05.1-33

TECHNICAL BULLETIN

**Incorrect Emission Control Label –
Install Revised Label – Canadian Vehicles
Service Action S691**

MODEL 1995 MY
XJR
VIN 720001-754303

LOCATION OF EMISSION CONTROL DATA LABEL

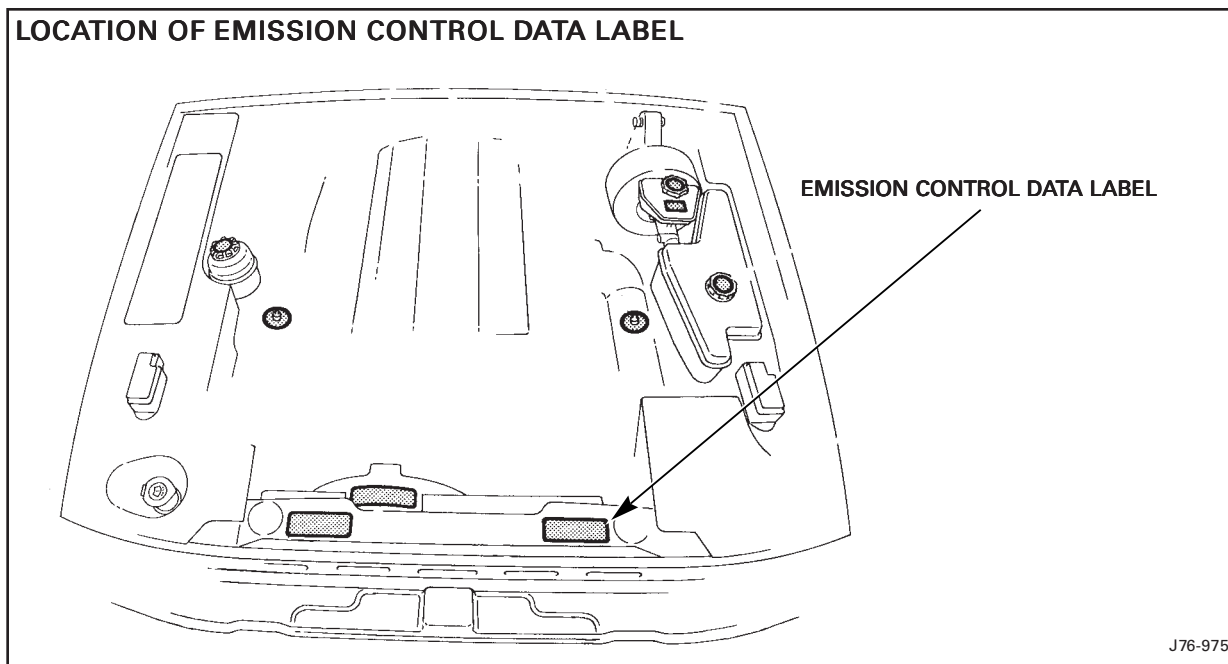
On all 1995 Model Year XJR Sedan Models within the above VIN range, the factory-installed Emission Control Data Label (“Tune-up Label”) was incorrectly specified. This label is applied to the crossmember above the radiator, within the engine compartment. 1995 MY XJ6 4.0L Sedan models with naturally-aspirated AJ16 engines are NOT affected.

The existing label implies that the engine is equipped with an Exhaust Gas Recirculation system which is not the case.

2. Identify the Emission Control Data Label ("Tune-up Label"), located on the left side of the cross panel above the radiator (Illustration 2).
3. Clean off the existing label.
4. Apply the replacement label over the old label.
5. Apply an R691 authorized modification label to the Driver side B-pillar. (This label will immediately indicate to any other Dealer that the vehicle concerned has already been rectified).
